November 20, 2023

ADDENDUM #1

Owen Valley Middle School Addition and Interior Renovations

SHEET NO: **A3**
14 of 58

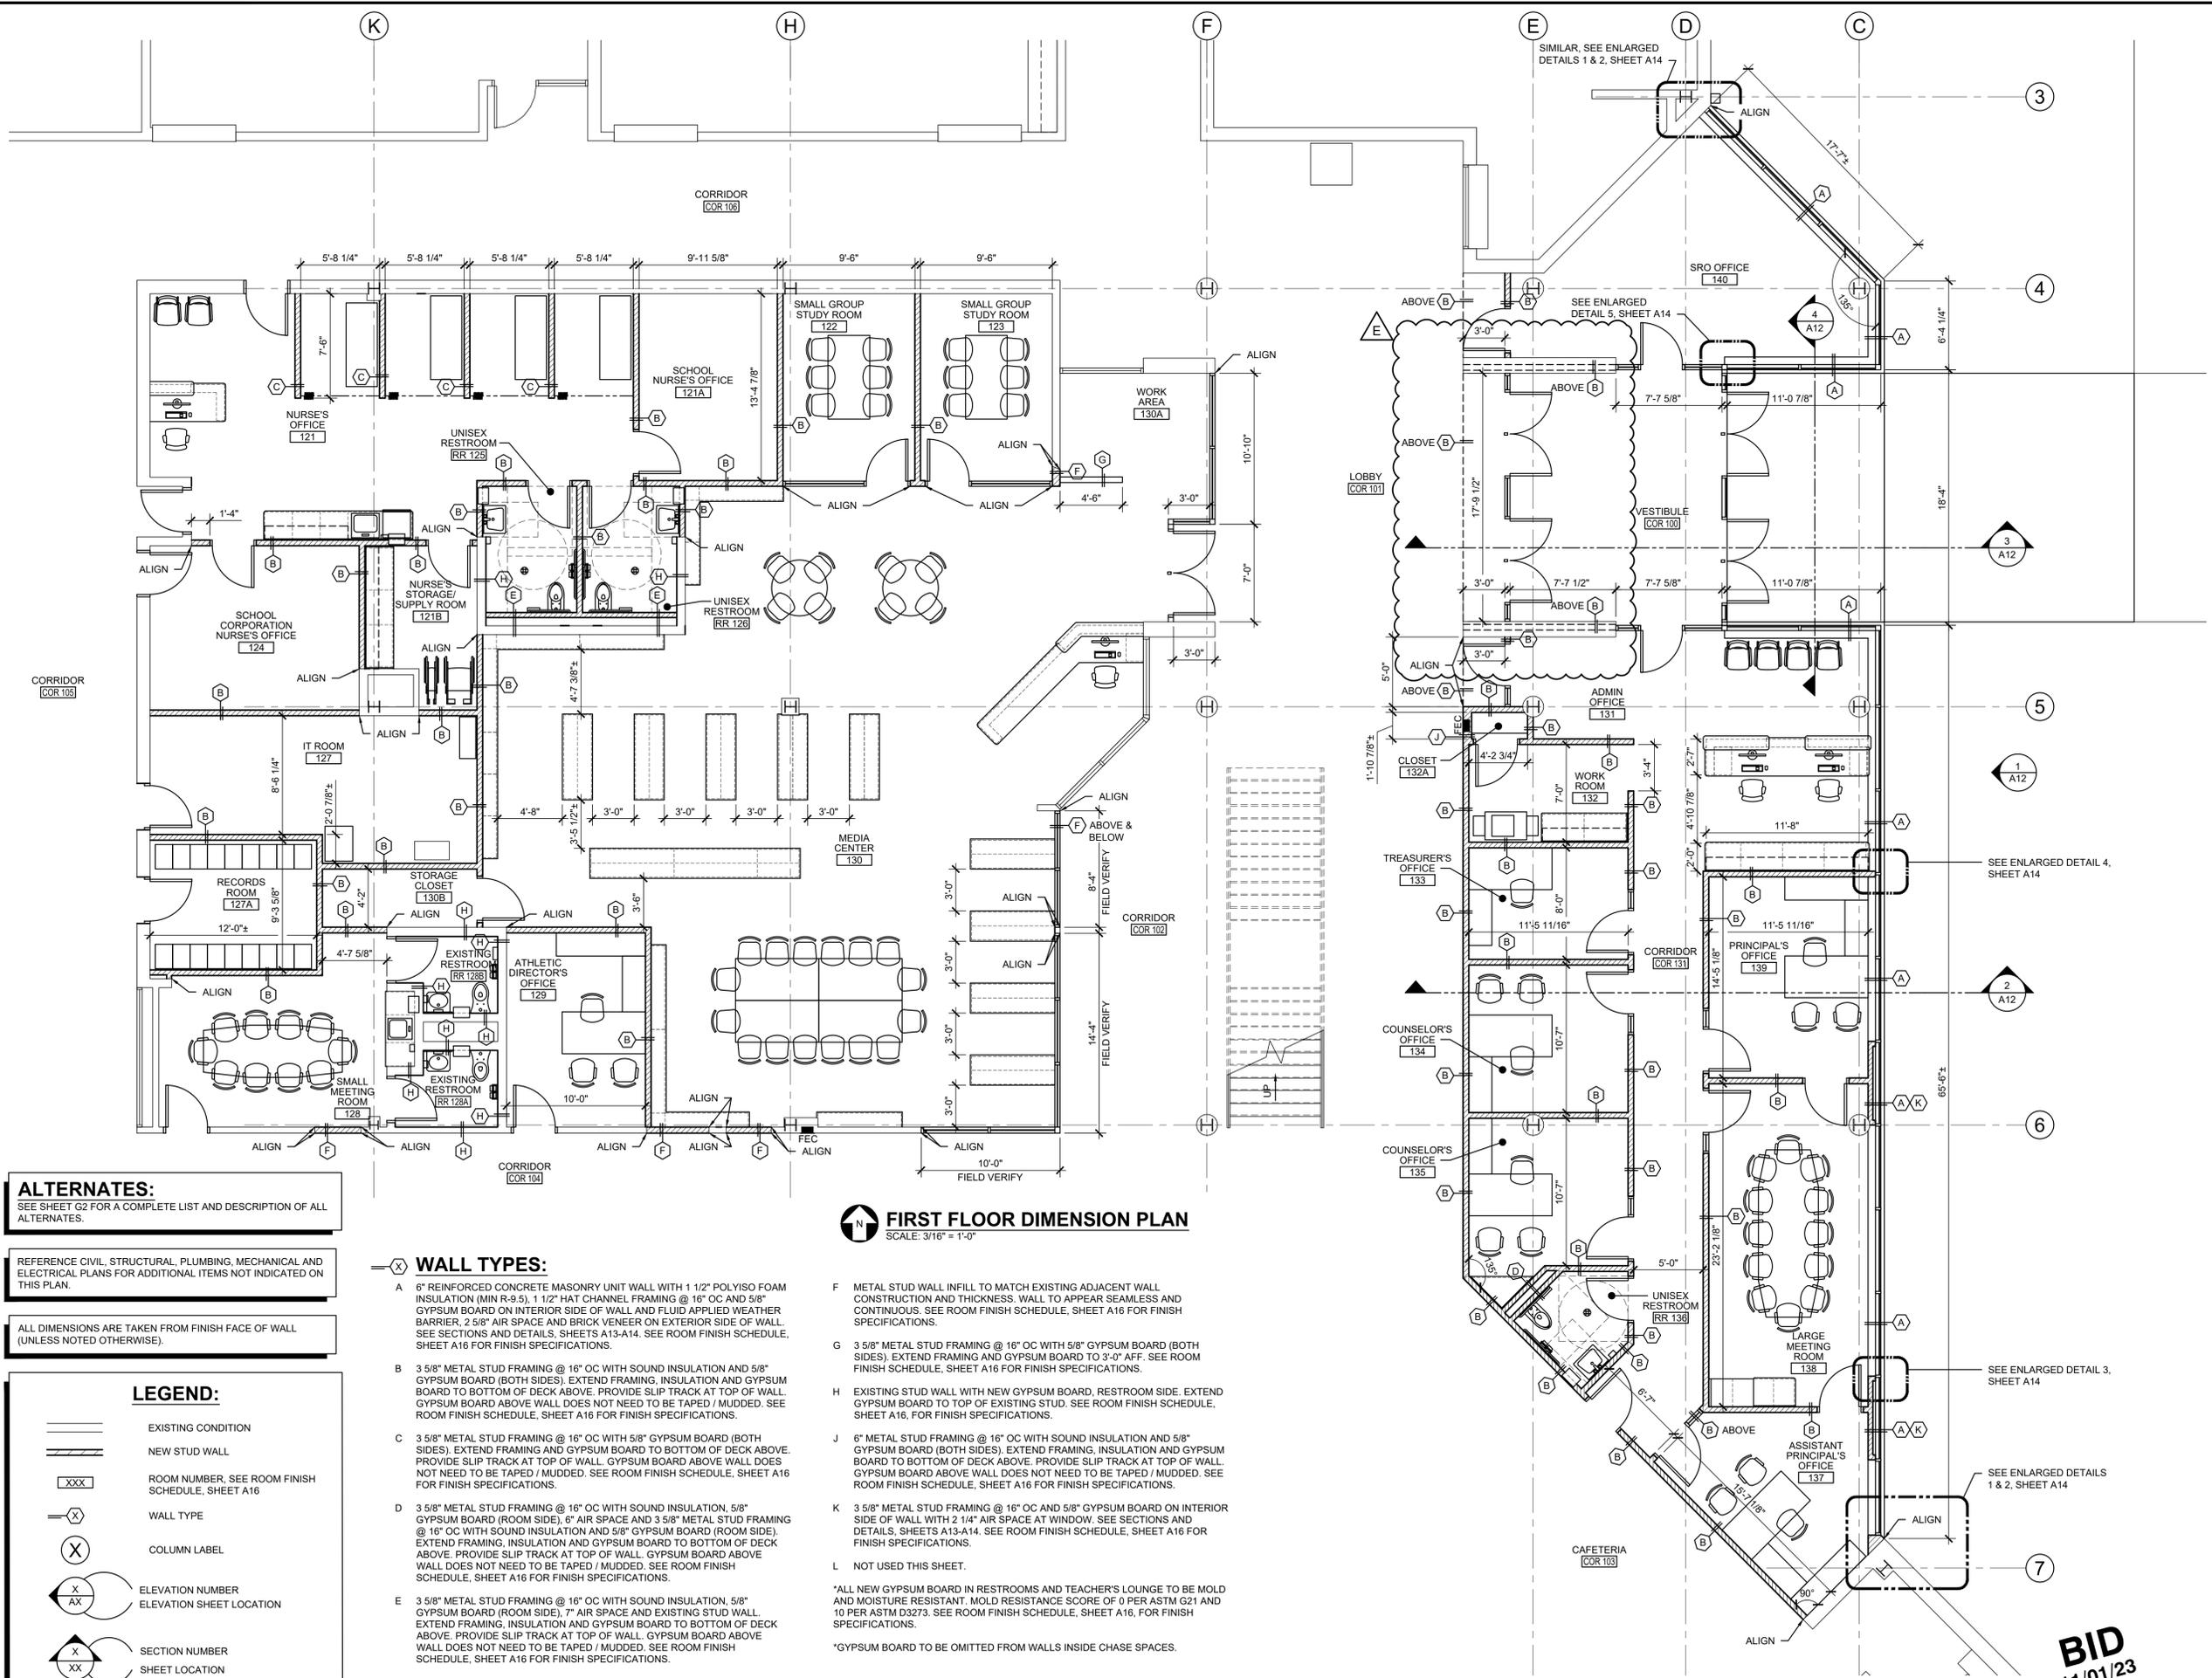
Sheet A3 - Wall type note has been added above the Vestibule to close off portal with ceiling above.

SHEET NO:
A7

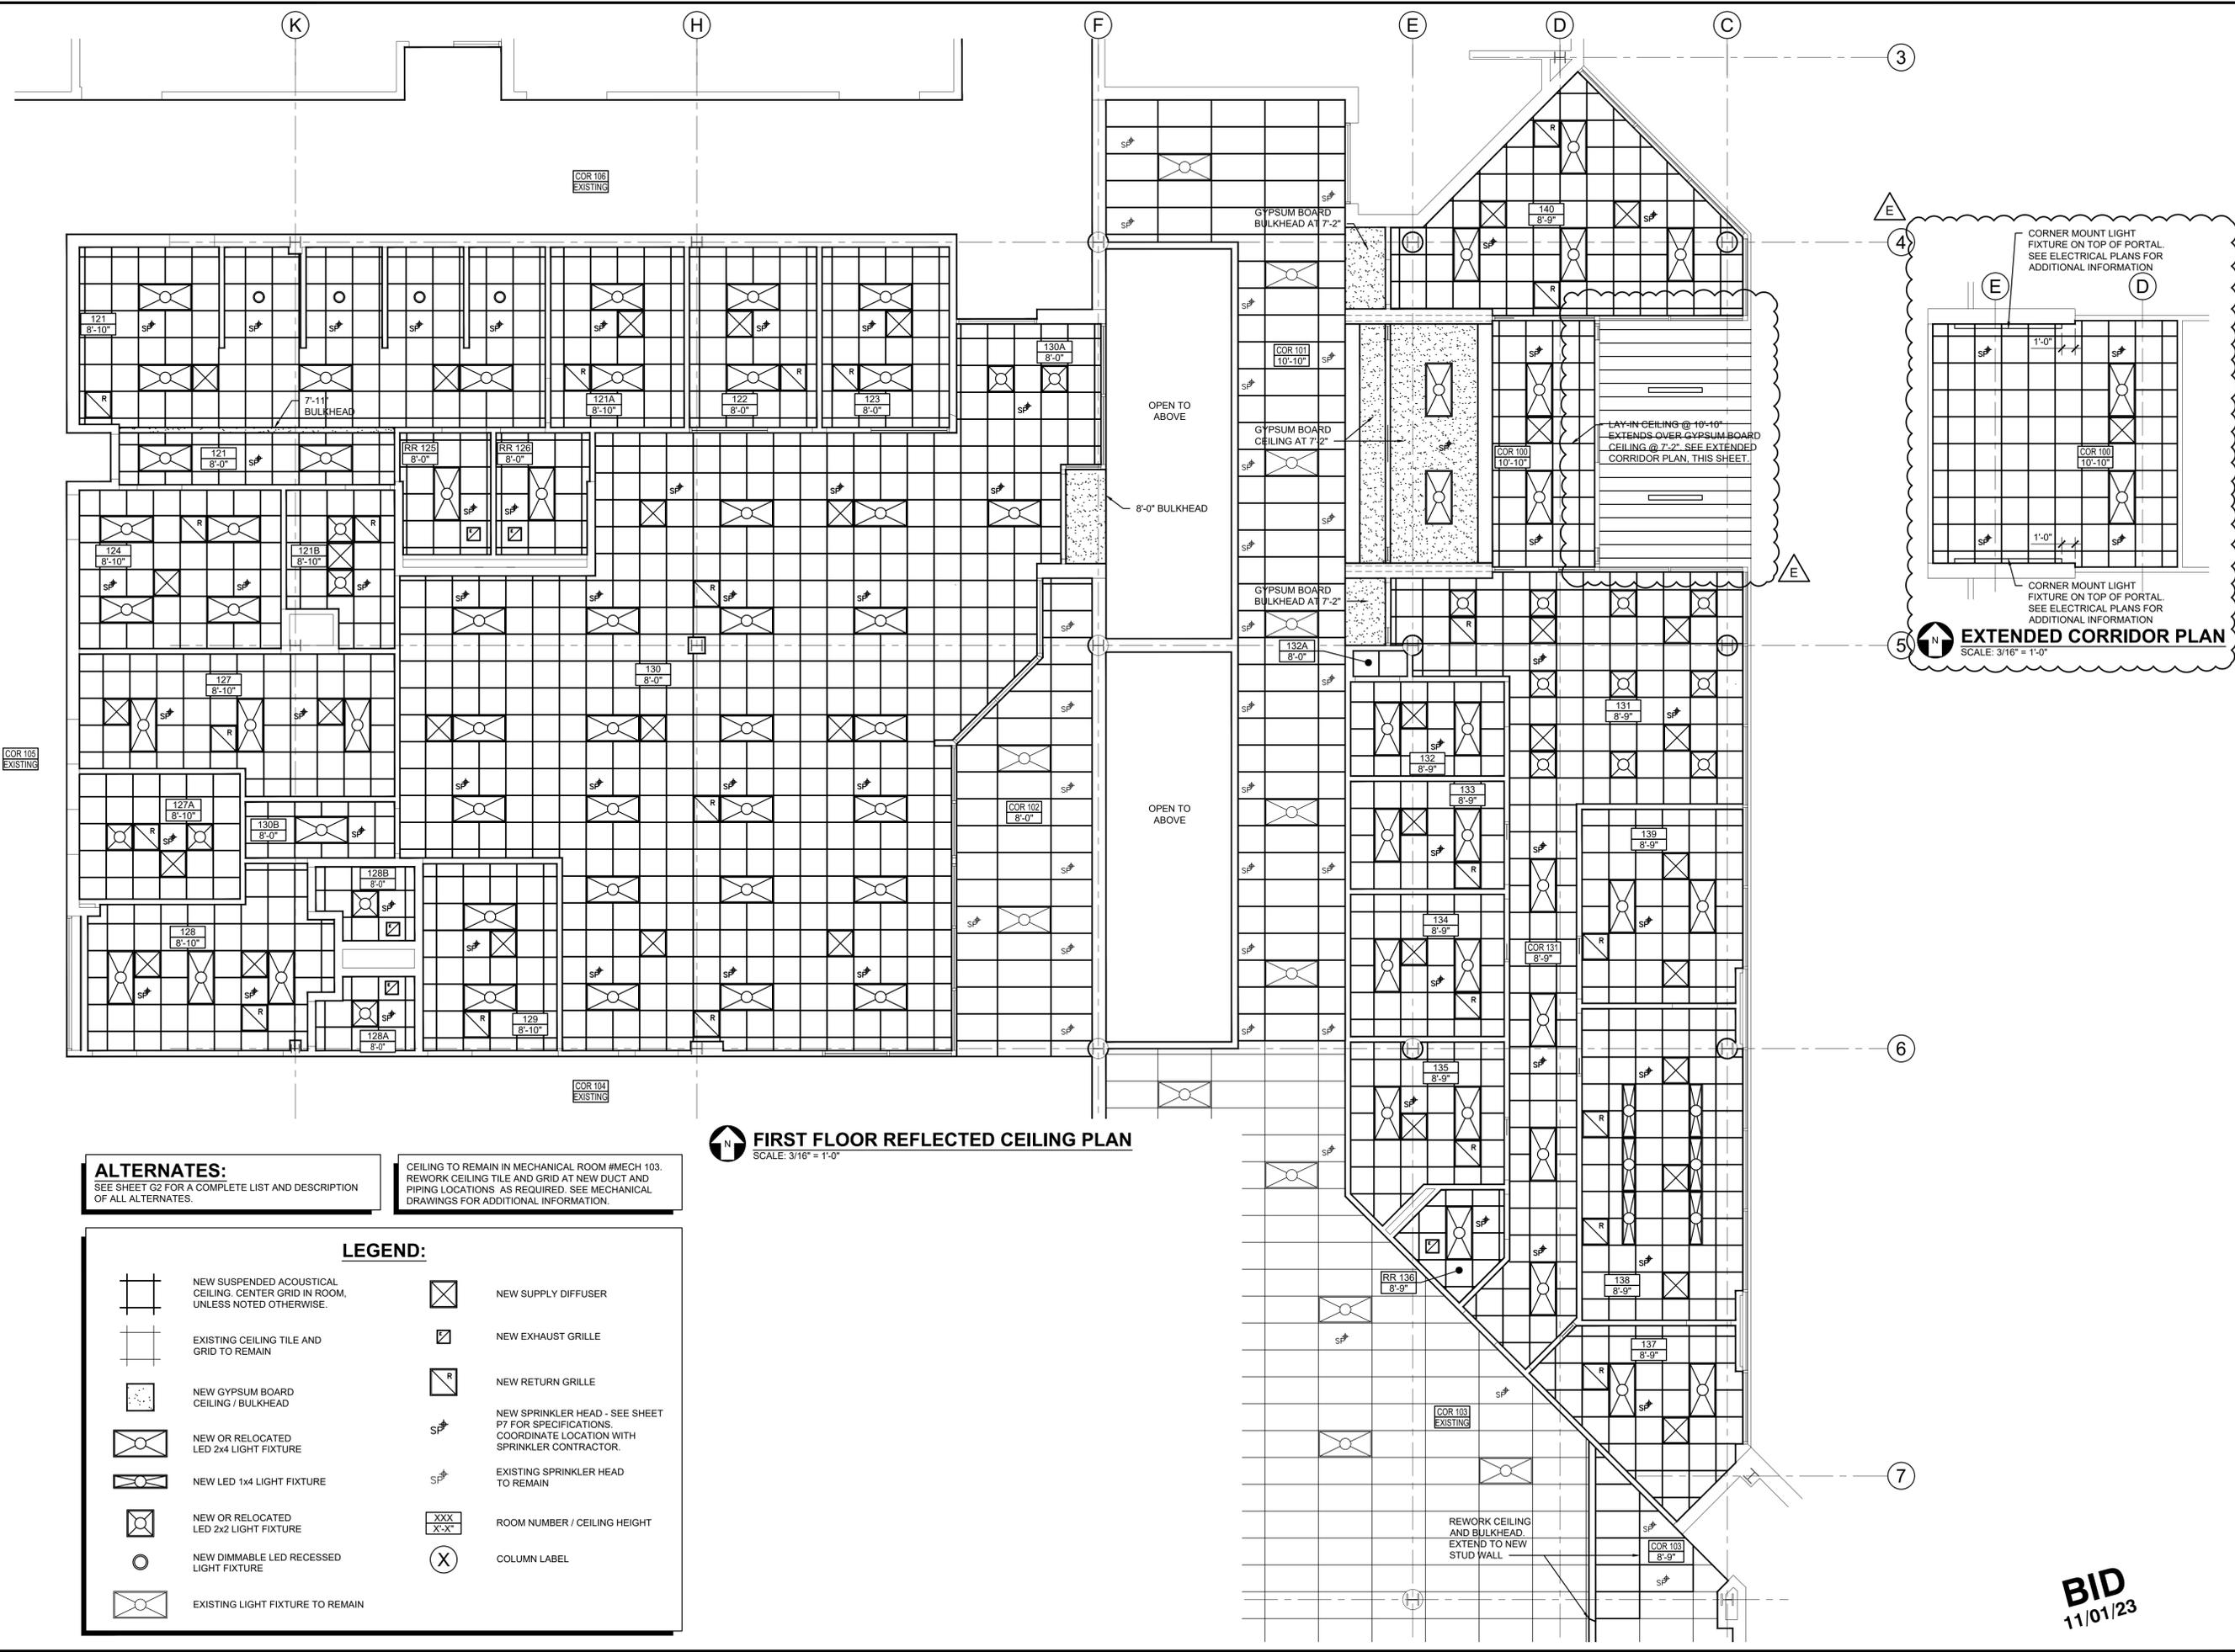
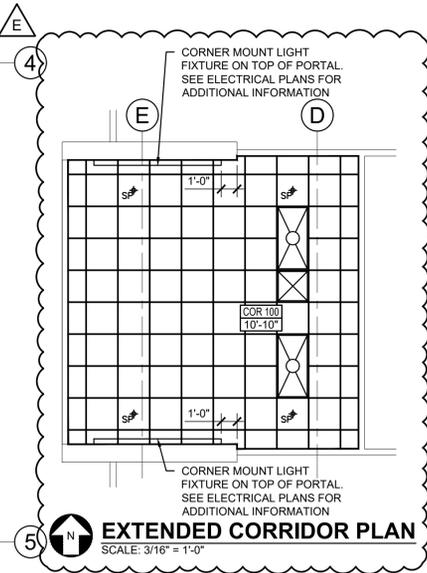
Sheet A7- Exterior soffit has been shown at the main entry. Lights at this location have been changed to a linear fixture. Lights have been modified on the Extended Corridor Plan.

SHEET NO:
A12
23 of 58

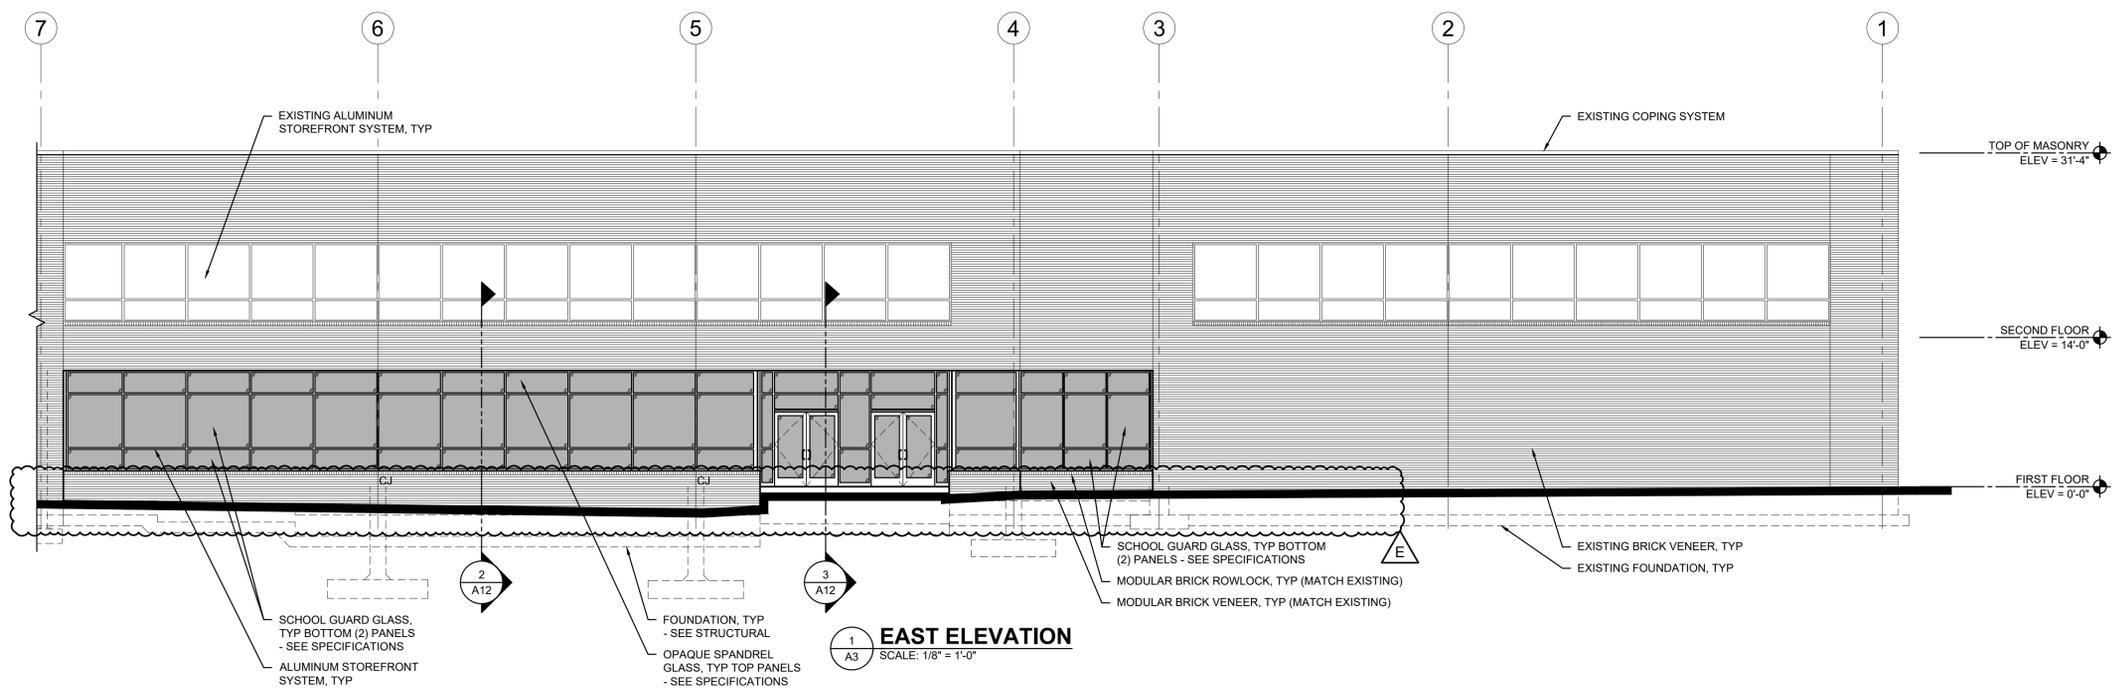
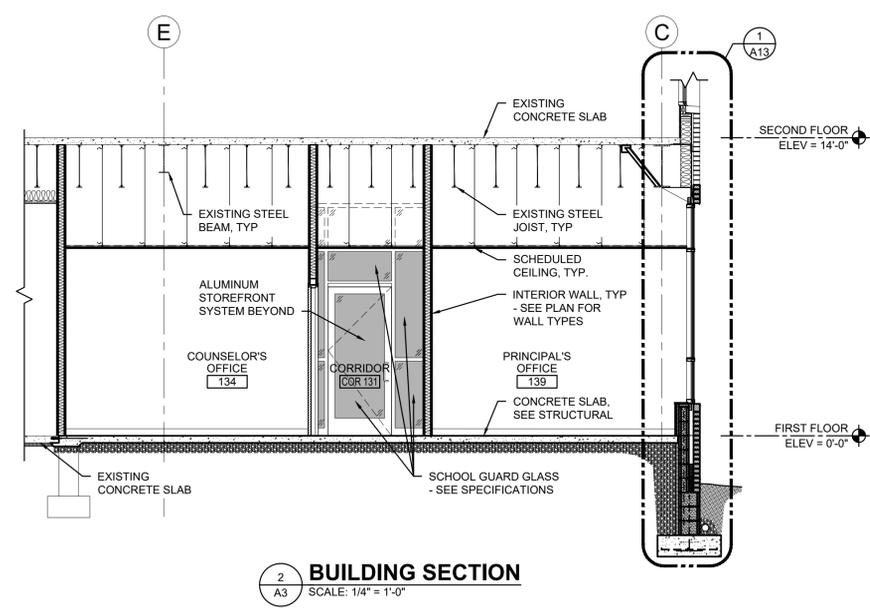
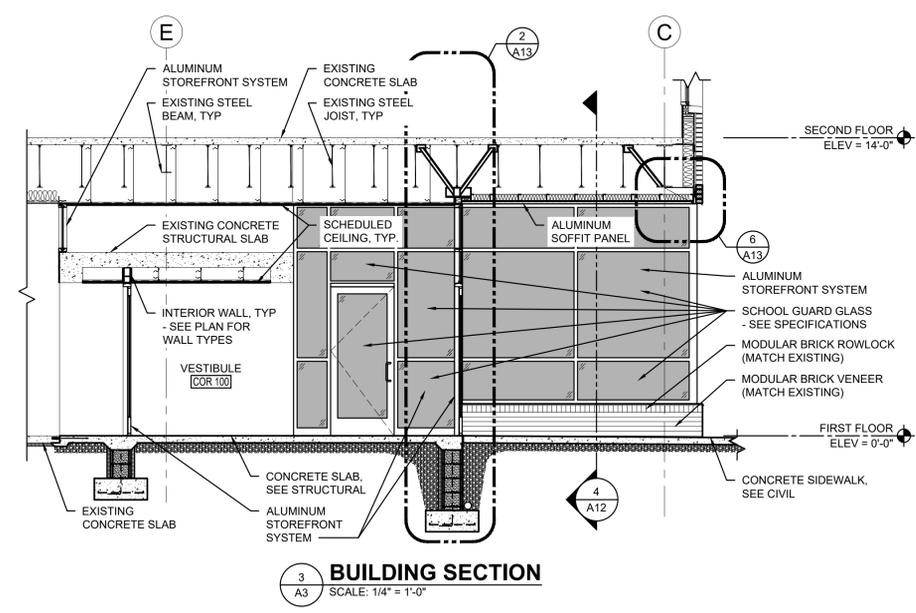
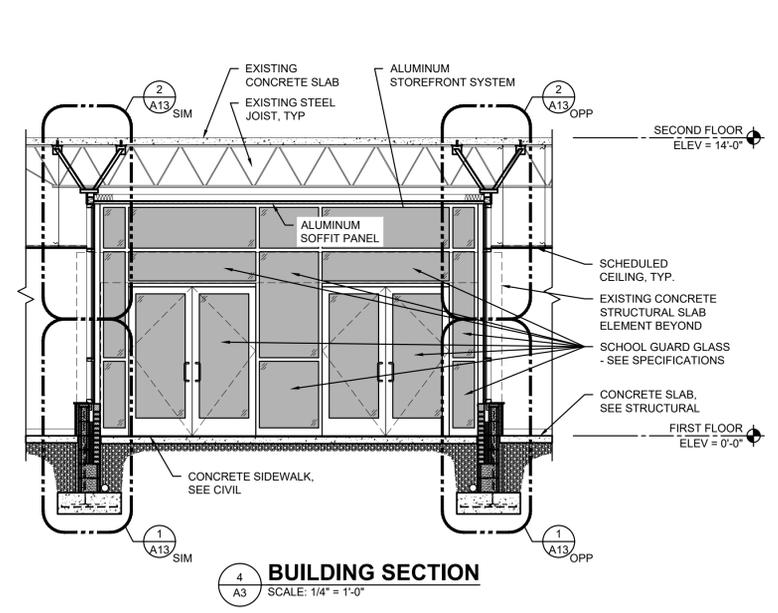
Sheet A12 - Updated grading on elevation to match Civil drawings.
